AMENDMENTS TO THE DRAWINGS

REMARKS

FIG. 9

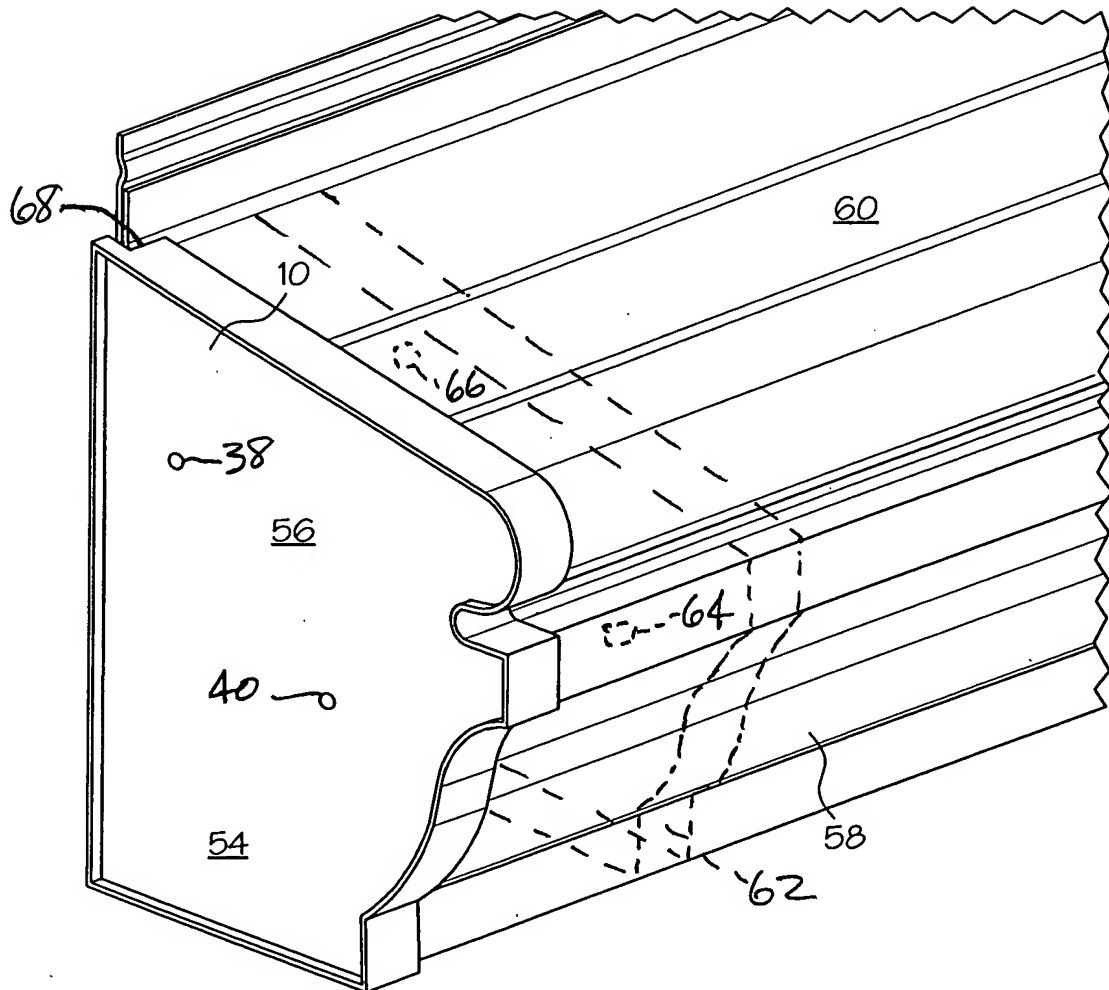
Appended hereto as an attachment is a replacement formal drawing sheet to replace sheet 3 of the drawings that were originally included in the application. The replacement sheet shows the bracket in dashed lines, it identifies by reference numerals the apertures that are involved in the interconnection of the end cap with the bracket, and it also identifies the gap recited in claim 7.

Also appended hereto is a copy of the originally-filed drawing sheet 3 showing in red the drawing changes that are reflected in the attached replacement drawing sheet.

In this Amendment specification paragraphs [0021], [0023], and [0024] are amended for clarification purposes. Sheet 3 of the drawings, containing Figure 9, has been amended to identify the bracket 62, the gap 68, apertures 38 and 40 of end cap 56, and respective associated apertures 66 and 64 in bracket 62. The showing of the bracket is based upon the originally-filed specification, paragraphs 0021 and 0024, which each disclose a bracket, its position in the gutter and its connection with end cap 10 by connecting screws that pass through apertures 38, 40 of end cap 10 and into apertures 66, 64 in bracket 62. No new matter has been added to the specification because the amendatory matter is based upon the application as originally filed, including the specification, claims, and drawings.

The drawings were objected to on the ground they did not show several of the elements recited in the claims. In that regard, the support bracket is shown in amended Figure 9. The first connection means is shown in the drawings as walls 22 and 32, 24 and 34, and 26 and 36, the outer and inner peripheral walls, which also define therebetween a connection slot, as described in paragraph 0020. The gap is shown in amended Figure 9 and is identified in amended paragraph 0024, in which the amendatory matter constituting the last sentence of the paragraph is based upon claim 7 as originally filed. The first gutter-trough closure region is shown in Figure 9 as region 54 and the second closure region as region 56. It is believed that one having only ordinary skill in the art would be able to comprehend the nature, function, and structure of the invention from the drawings and the verbal description contained in the application.
